Wiring deltas easYgen-3100/3200/P1/P2 versus easYgen-3100XT/3200

Justin Schneider - 2026-07-27 - [easYgen-3000XT](#)

Analog Inputs:

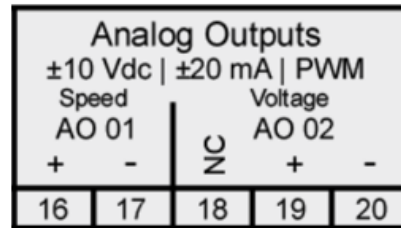
In old easYgen-3000 resistive senders up to 500Ohm and 0/4-20mA were supported. In 3000XT resistive inputs were increased to 2000Ohm and 0-1VDC senders are possible as well.

Communication Interfaces:

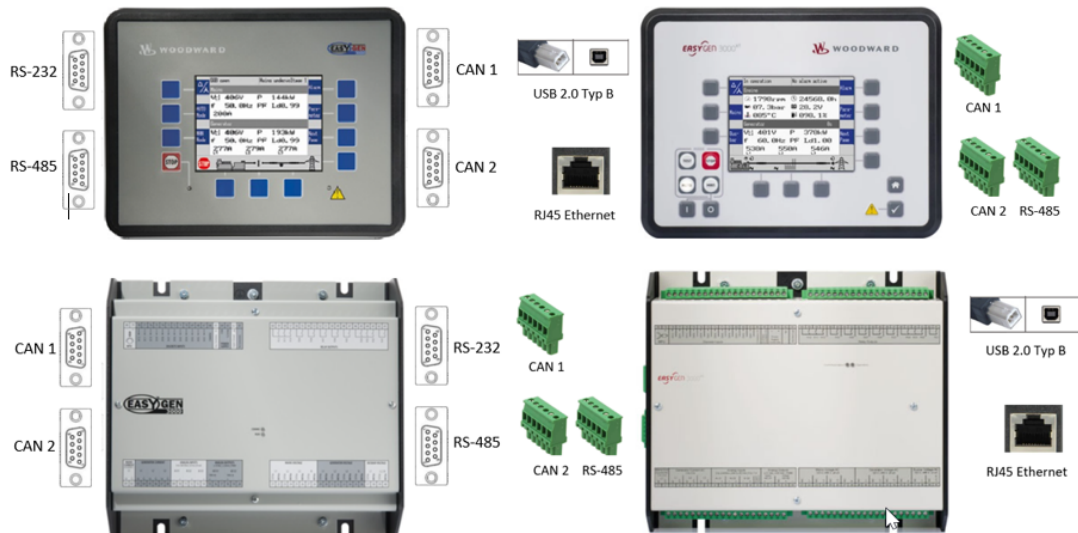
Old easYgen-3000 had D-sub sockets. RS232 port is used for Toolkit configuration. In easYgen-3000XT RS232 port was replaced by a USB 2.0 service port socket. In easYgen-3000XT D-sub sockets are replaced by terminals
